Q-dummies Modification History

GRSP Informal Group CRS Testing – Brussels October 07, 2008

Memorandum prepared for GRSP:
Q- dummies Modification History

Neck durability improvement (Q1, Q1.5 and Q3)

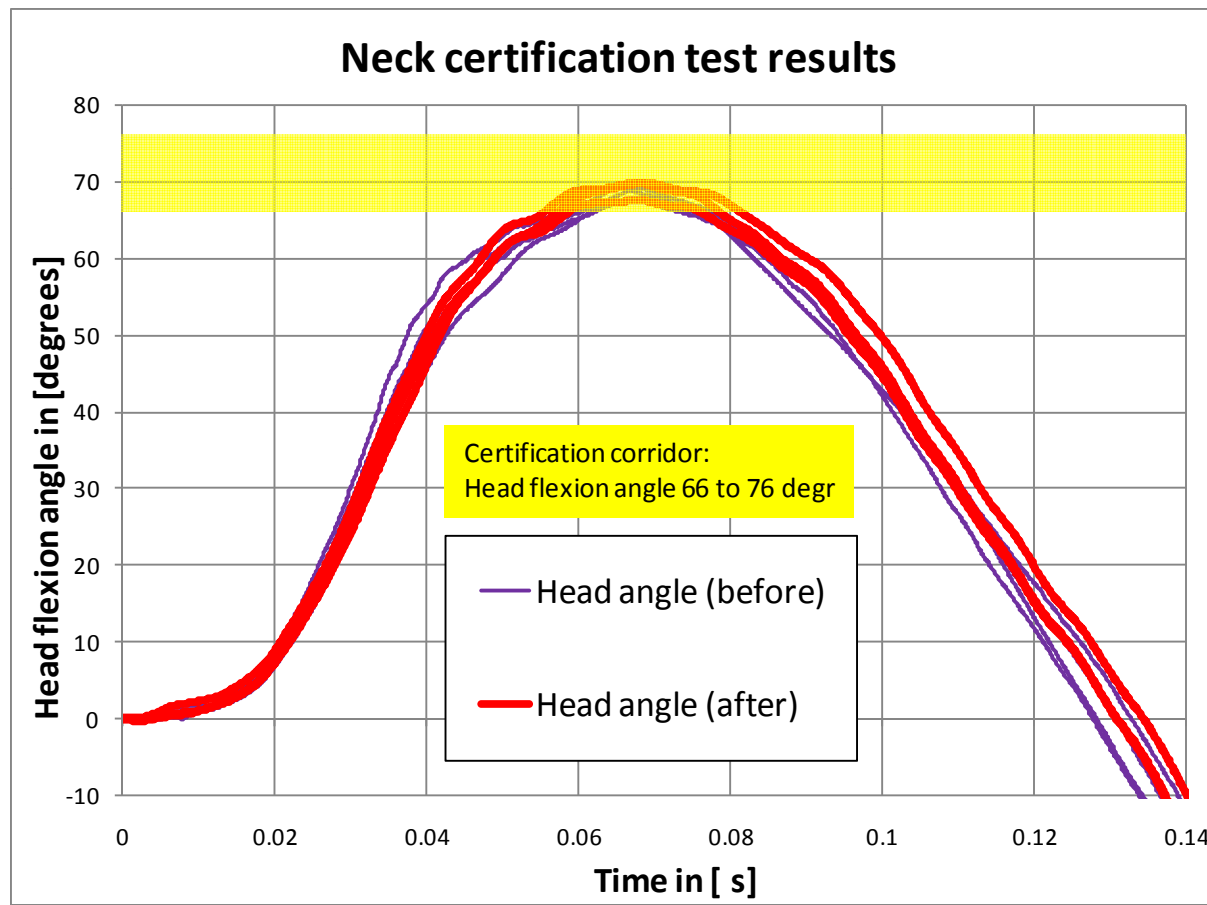
Part : Q3 Neck Assembly (also for Q1 and Q1.5) PN: 020-2100

What : *New material vendor that guarantees consistency rubber.
Mould shape slight changed to reduce stress concentration.*

Why : *Necks showed small surface cracks in rubber and some users reported neck failures.
Process control at vendor not appropriate.
Other material vendor selected.*

When : *Start in June 2006 and was solved in November 2006.
Customers got replacement parts free of charge.*

Implications:

*No affect on bending performance characteristic.
Old parts can be used as they are.*

Rib cage durability (Q3 only)

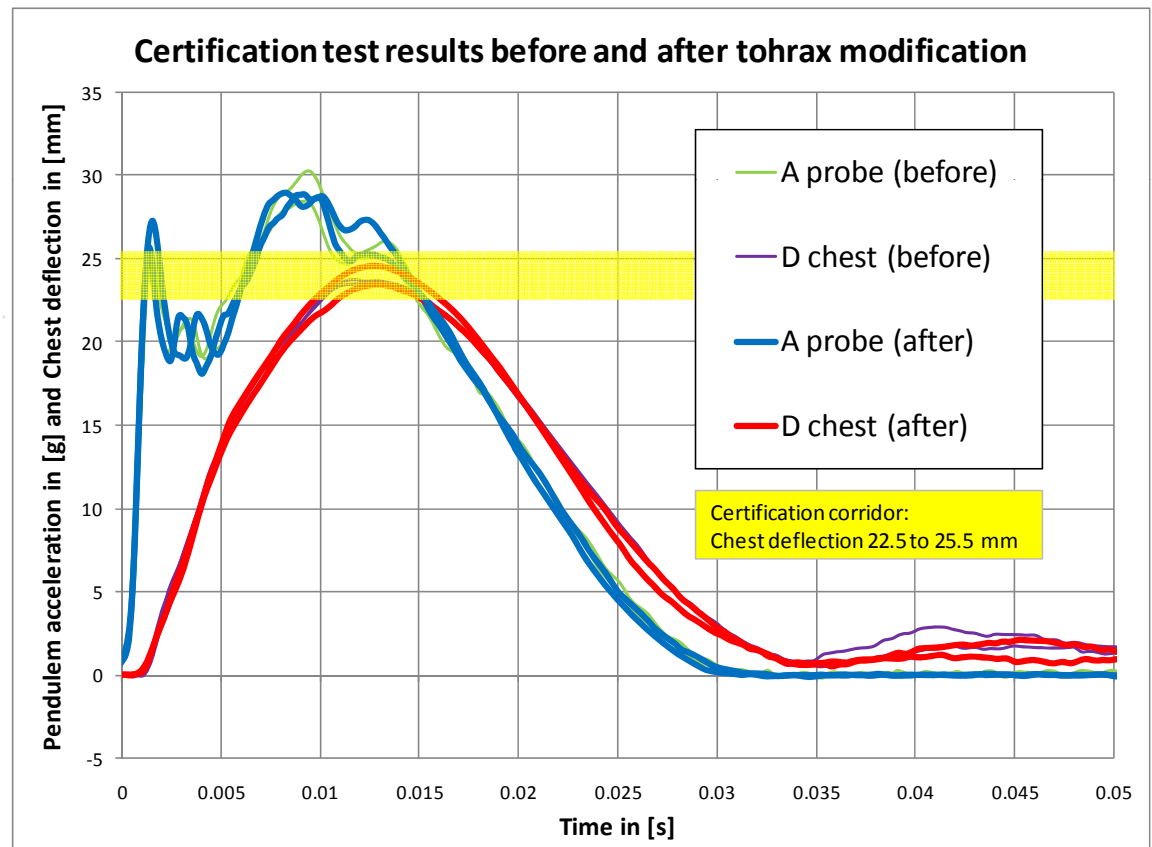
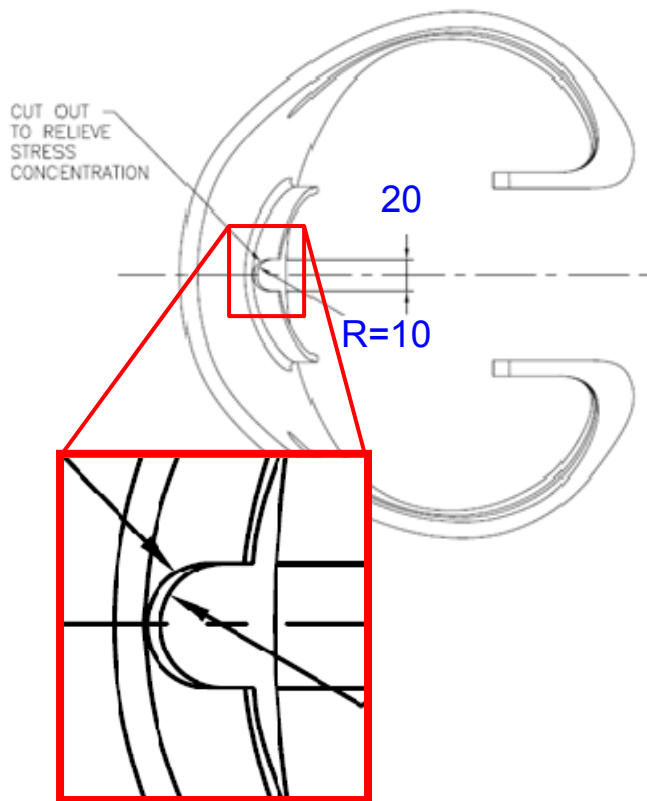
Part : Rib Cage Assembly PN: 020-4100

What : Radius cut out at mid sagittal plane in upstanding flange of rib cage at clavicle mount location.

Why : Customers suffered early crack initiation. High stresses in top of flange due to bending promotes fatigue crack initiation.

When : May 2007 Parts identification controlled by serial number

Implications:

No affect on stiffness of ribcage section.

Improved fatigue life for frontal impacts.

No affect on impact performance of the rib cage.

Old parts can be used as they are.
